**MEMORANDUM**

**TO:** District of Columbia Zoning Commission

**FROM:** Jennifer Steingasser, Deputy Director Development Review & Historic Preservation

**SUBJECT:** Setdown Report: ZC 11-24, Consolidated PUD and related Map Amendment from the R-4 to C-2-B zone at Square 901, Lot 801 (former Hine Jr. High School)

# L02 PLAZA WEST + 7TH ST. NORTH / DETAILED SITE PUBLIC SPACE + LANDSCAPING PLAN

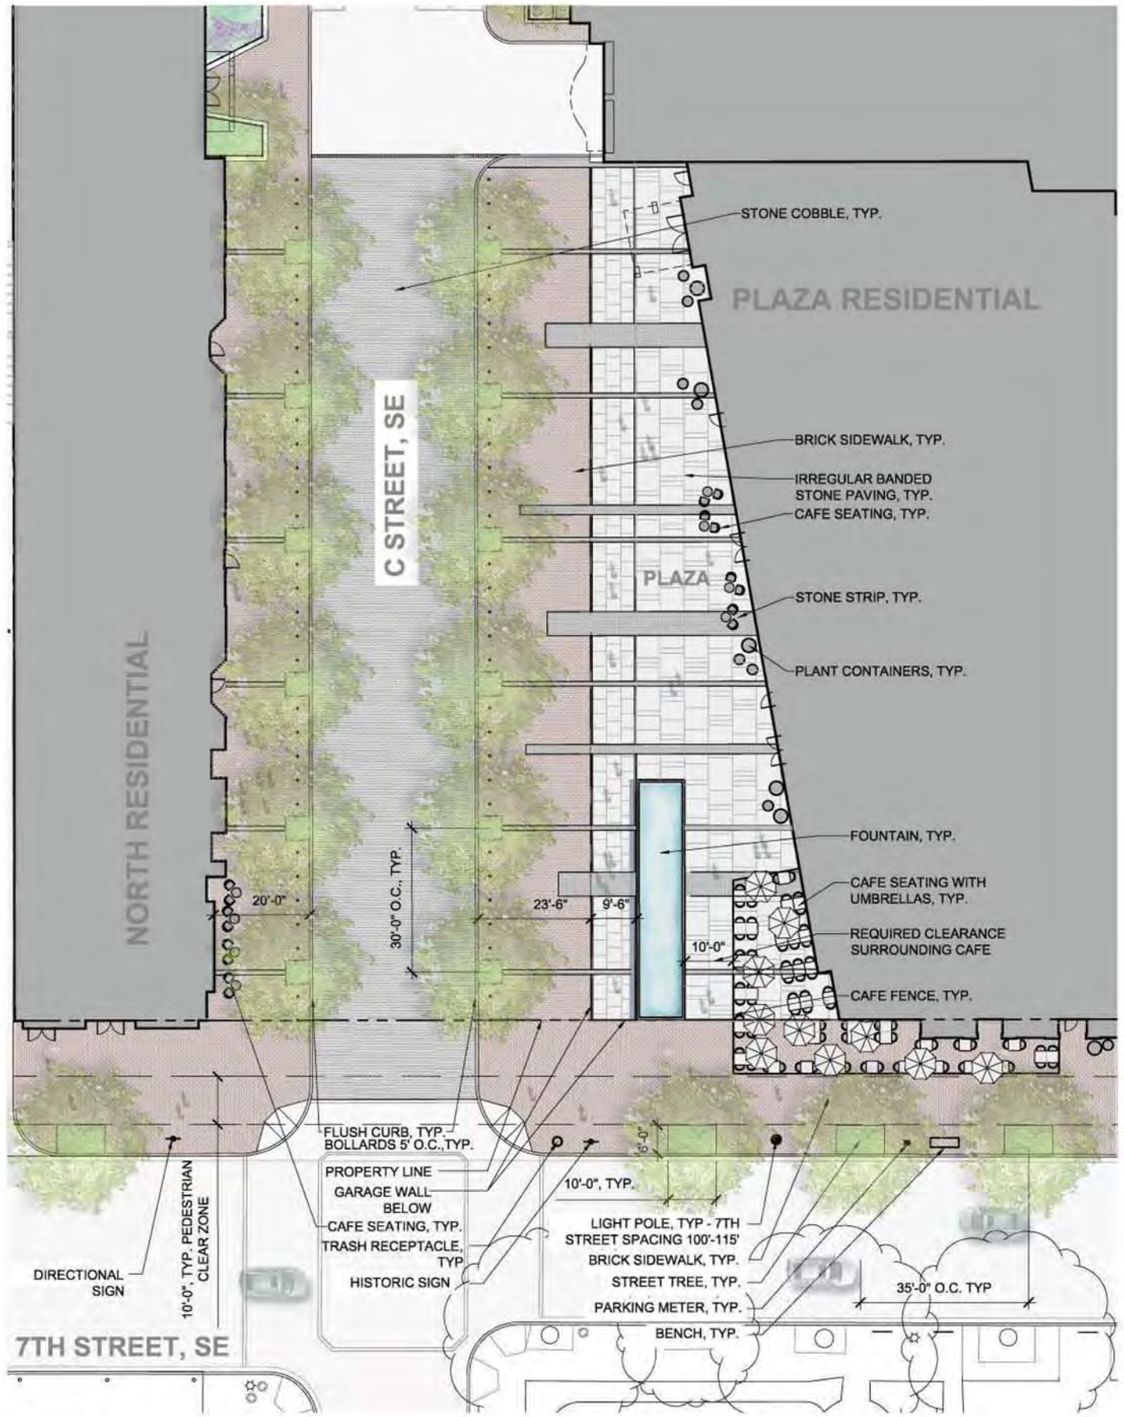
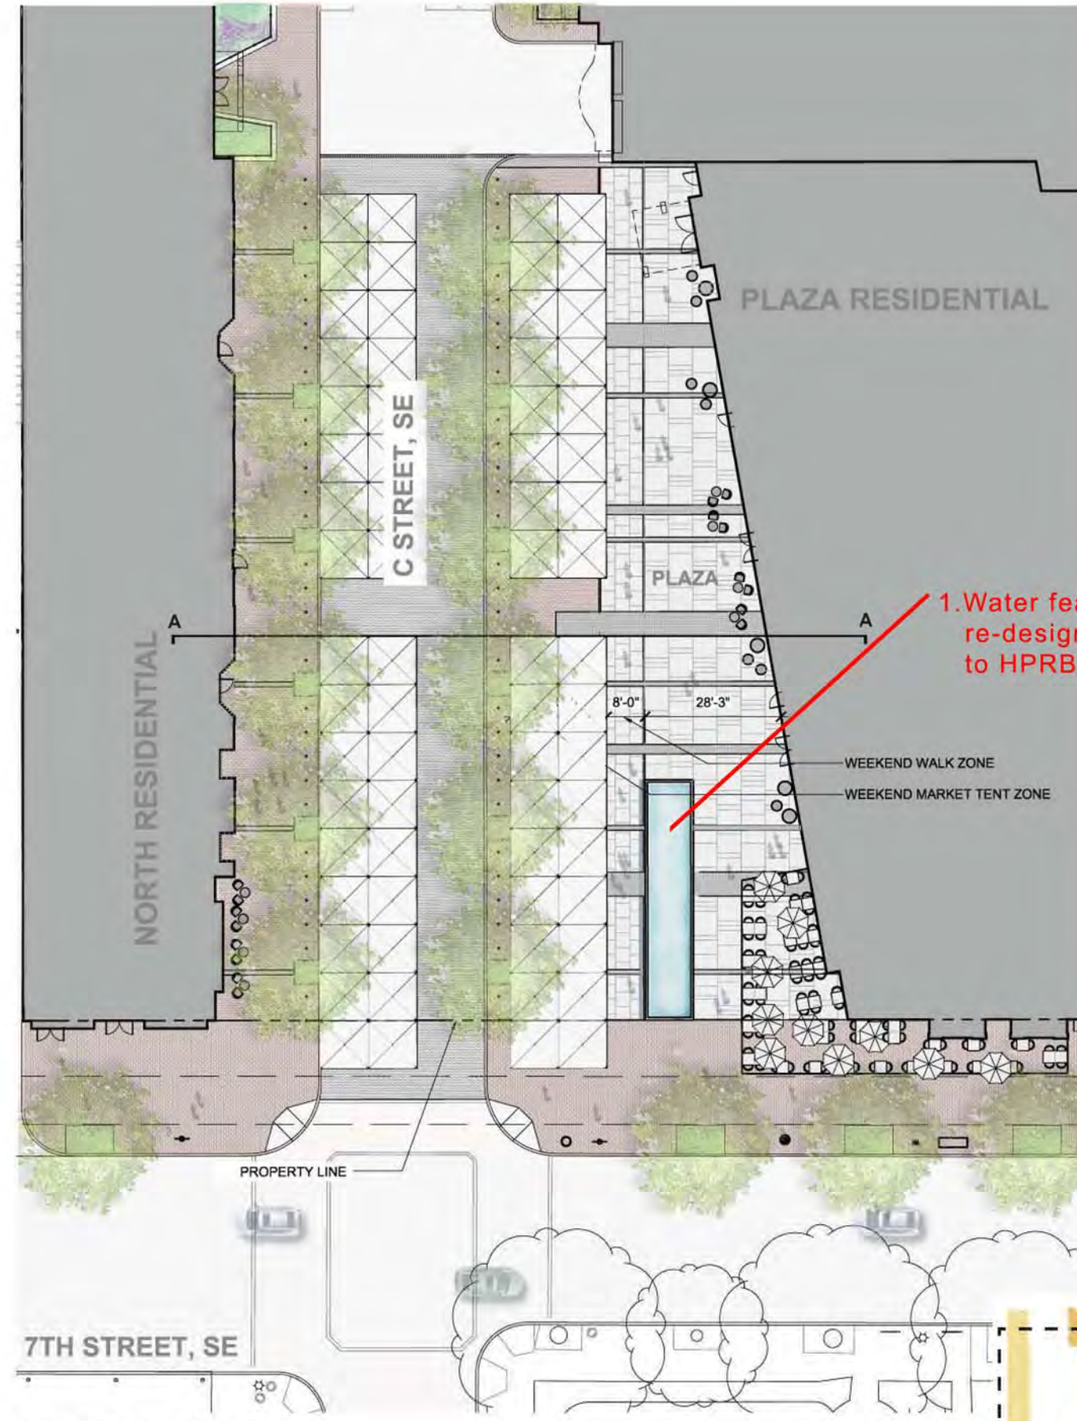
- Various concerns were expressed by HPRB about the proposed water features, including that they are often not successful year-round and potentially take up space that could be used for other uses (e.g. more market tents). Suggestions made for further study included that water features be eliminated, that they have ledges that could double as seating, and that they be flush with ground plane so that space can be programmed for alternative uses when not in use.
  See drawing note #1. Being actively studied. Final proposal will be presented to HPRB.

1.Water feature will be re-designed in response to HPRB comments.

**A 35 SOUTH BUILDING - ENLARGED ELEVATION - 8TH STREET COMPONENT - LOOKING WEST**

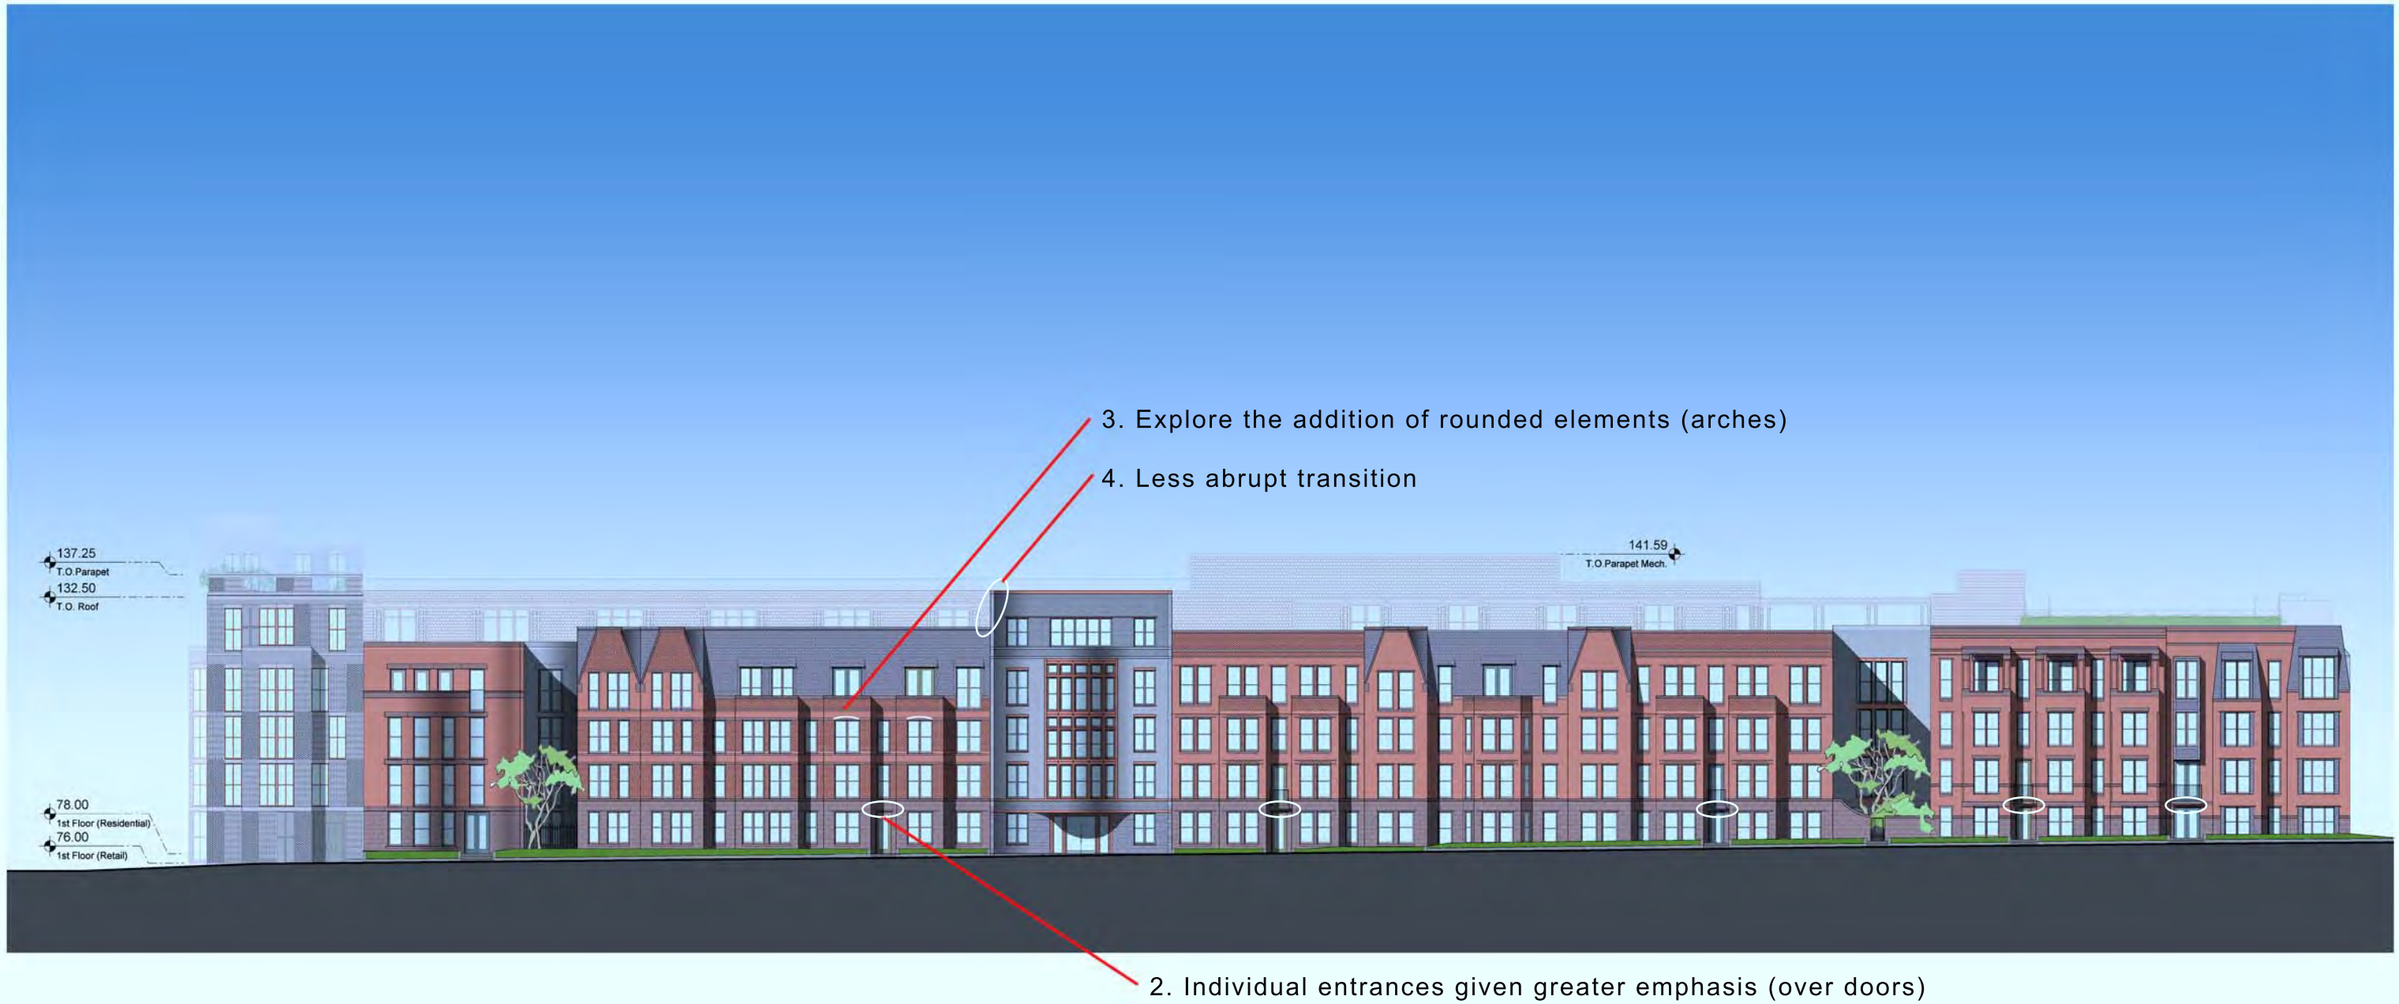
- The individual entrances should be given greater prominence and distinction, and the fenestration refined with the goal of introducing additional variety.
  See drawing note #2. Being actively studied. Final proposal will be presented to HPRB.

- The use of rounded, non-rectilinear elements – windows, dormers, oriels, ironwork – should be explored to break up the rectilinear character of the row.
  See drawing note #3. Being actively studied. Final proposal will be presented to HPRB.

- The five story lobby entrance element doesn't need to be lower or set back from the face of surrounding buildings but could be less abrupt.
  See drawing note #4. Being actively studied. Final proposal will be presented to HPRB.

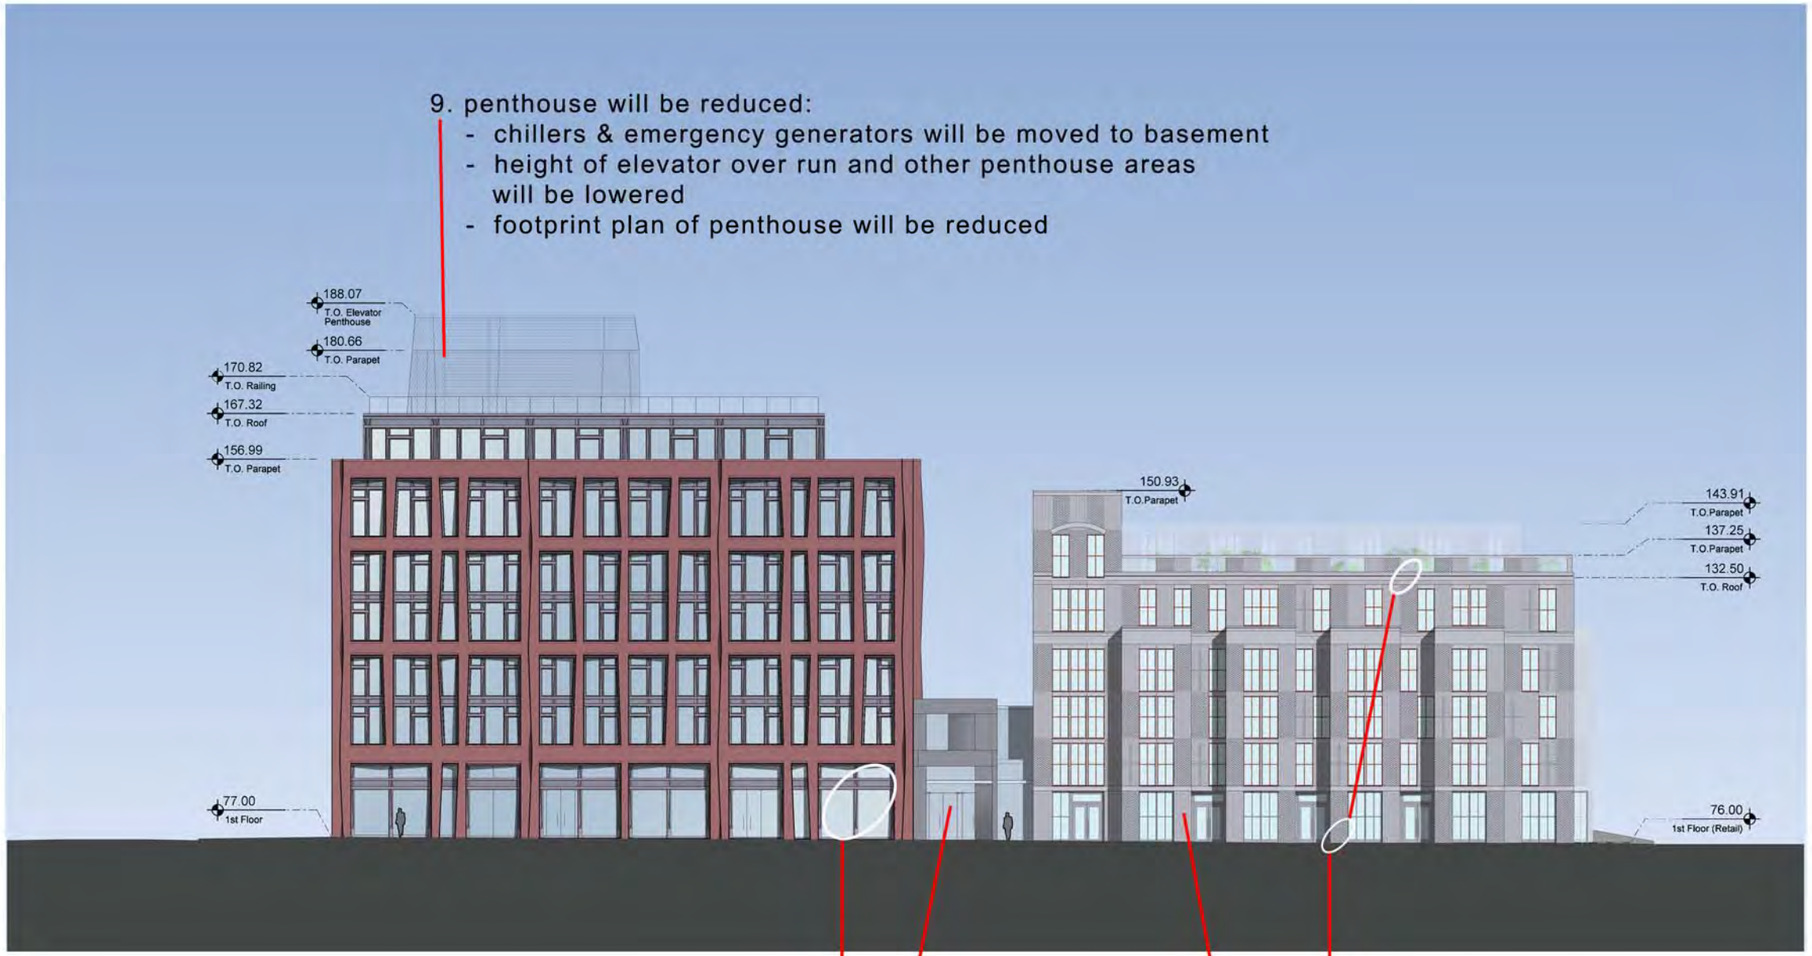
- Building is still a little too square and with perhaps too much of the lacey, patterned brick work.
  See drawing note #5. Being actively studied. Final proposal will be presented to HPRB.

- The retail base needs further development to ensure that it has visual interest and an appropriate scale for pedestrians; should relate more closely with the feel of retail on Capitol Hill. Study using projecting or smaller scaled storefronts, solid bases to the storefronts, and/or awnings that would provide a three-dimensional character. The corner in particular should be reevaluated to encourage connection and continuity between 7th Street and Barrack's Row.
  See drawing note #7. Being actively studied. Final proposal will be presented to HPRB.

- To minimize their footprints, the penthouse levels should be utilized exclusively for mechanical equipment; alternative locations within the body of each building should be found for amenity spaces. Where possible and necessary to reduce their size, absorbing mechanical functions within the body of buildings should be explored. Explore use of geothermal systems to reduce size of penthouses, and study eliminating the public roof deck to allow penthouse to be pushed further back.
  See drawing note #9. Being actively studied. Final proposal will be presented to HPRB.

9. penthouse will be reduced:
   - chillers & emergency generators will be moved to basement
   - height of elevator over run and other penthouse areas will be lowered
   - footprint plan of penthouse will be reduced

7. Scale retail storefronts to pedestrian Capitol Hill scale

5. Introduce flat brick courses at building's base (other flat brick already added after HPRB) Study cornice to relieve "squareness".

EAST - 8TH STREET SE

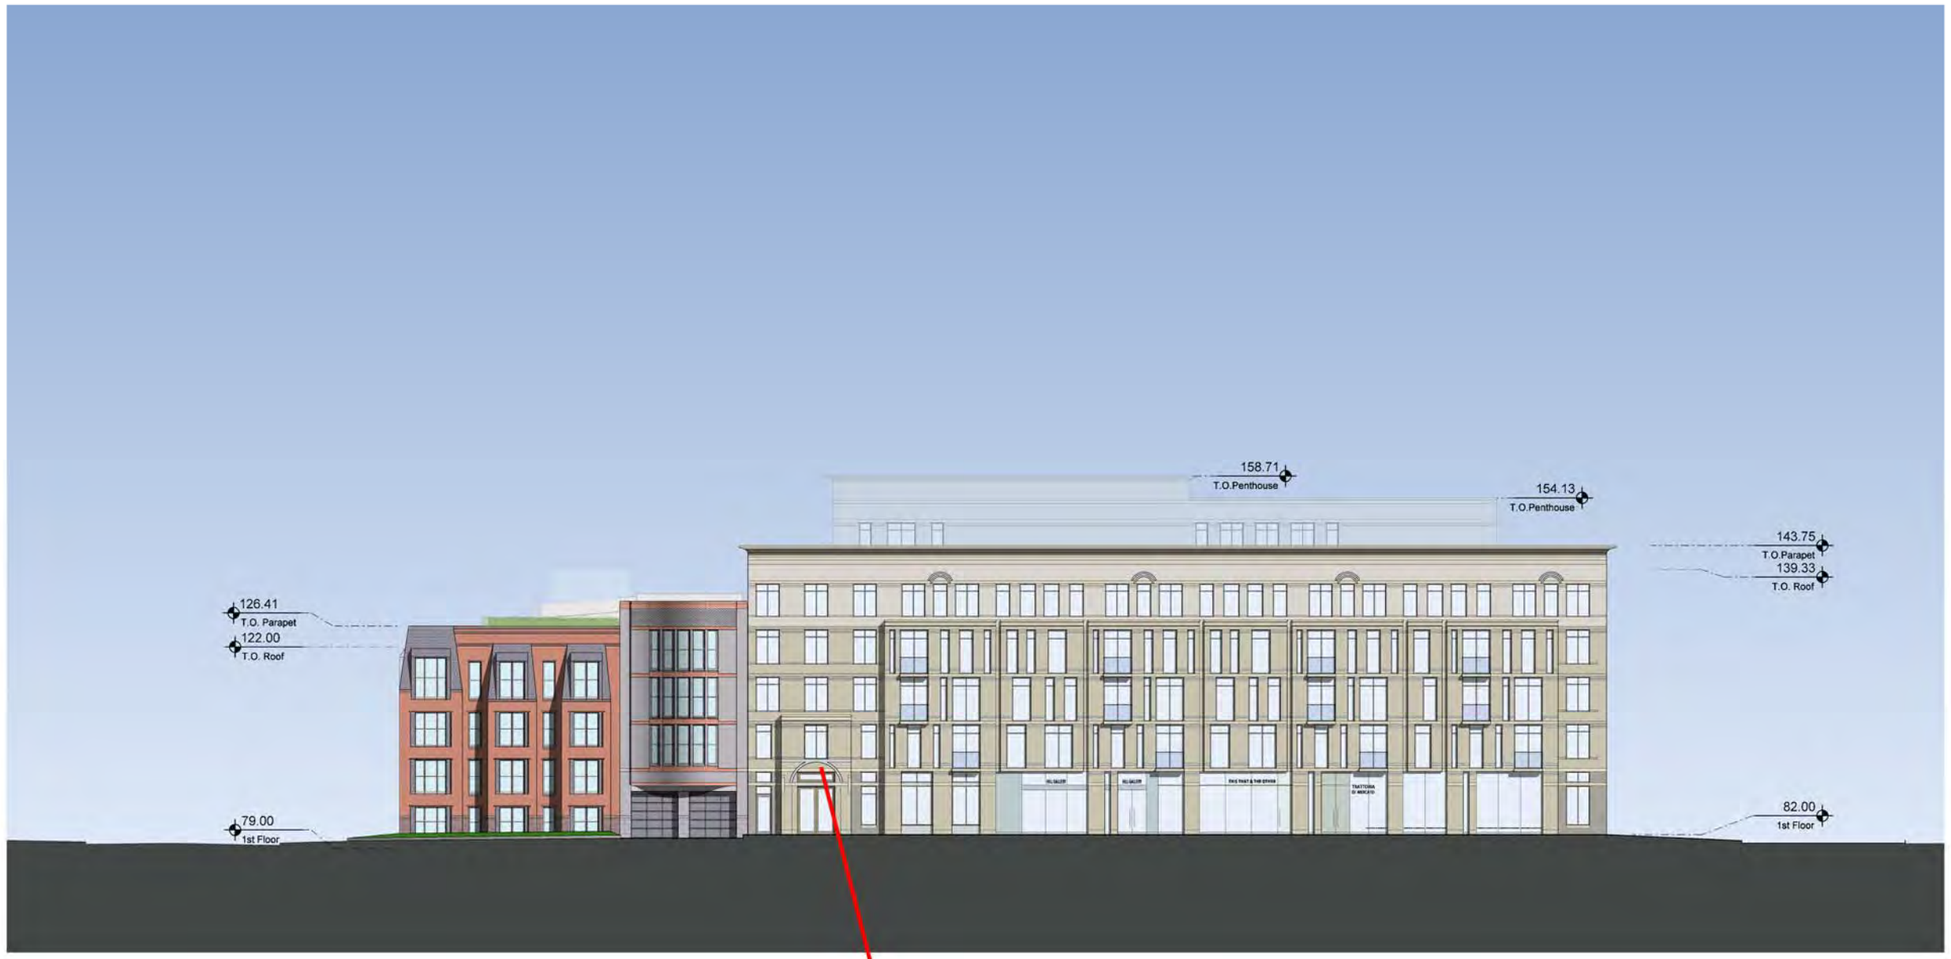
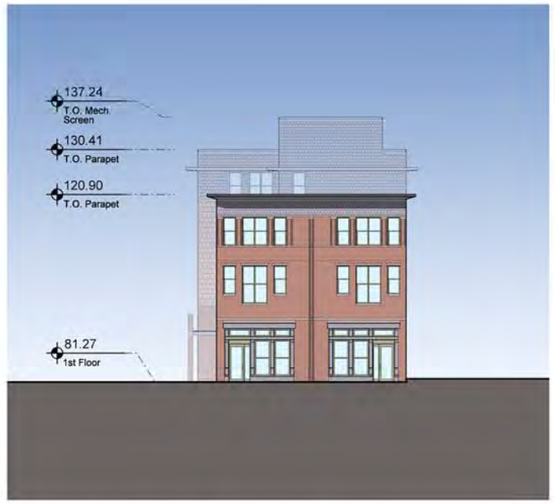
- Entrance to apartment building needs further development to be made residential in character. Suggestions for study included redesigning canopy, relocating entrance, and eliminating two-story projecting pavilion.
  See drawing note #12. Being actively studied. Final proposal will be presented to HPRB.

12. re-design entry canopy,
study 2 story projection

NORTH - PUBLIC ALLEY

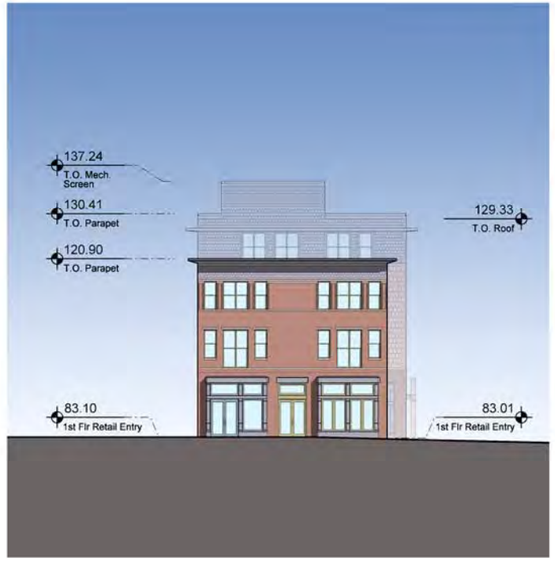
- Rear (alley) elevation of four-story element needs additional development; does not need to be made commensurate in design to front elevation, but will be visible and needs to have a stronger sense of being designed.
  See drawing note #14. Being actively studied. Final proposal will be presented to HPRB.

14. add "stronger sense of design to alley elevation - will study adding base for tri-partite reading
